Notice of Allowability

10/501,034

HUPERZ, ULRICH

Fig. 1

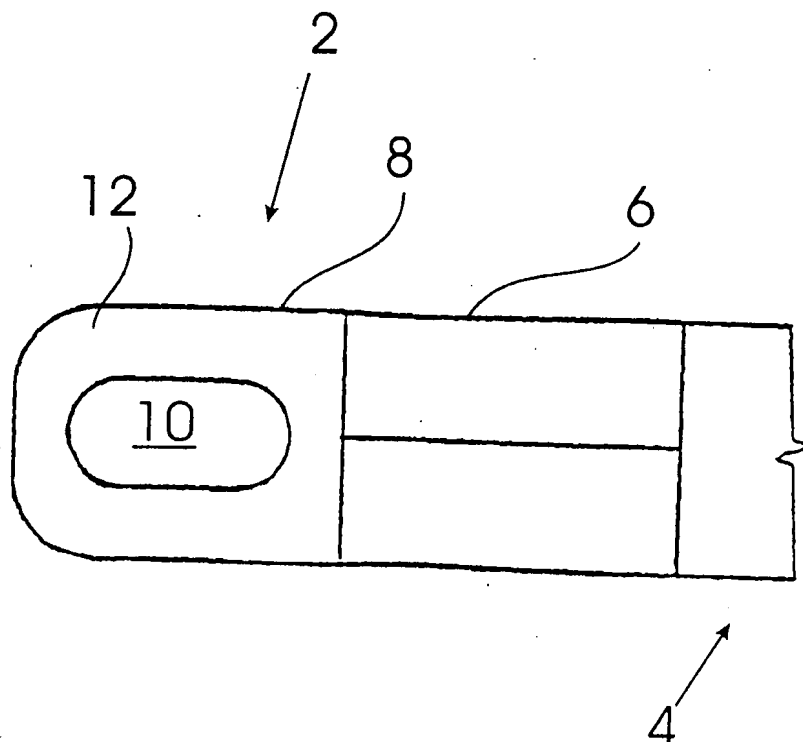
2. The following changes to the drawings have been approved by the examiner: Proposed replacement sheets of Figures 1 and 2 are approved, as is the new sheet of Figure 3. However, Figure 2 will be changed so that the lead line for reference numeral 14 does not extend past the layer of film. In order to avoid abandonment of the application, applicant must make these above agreed upon drawing changes.
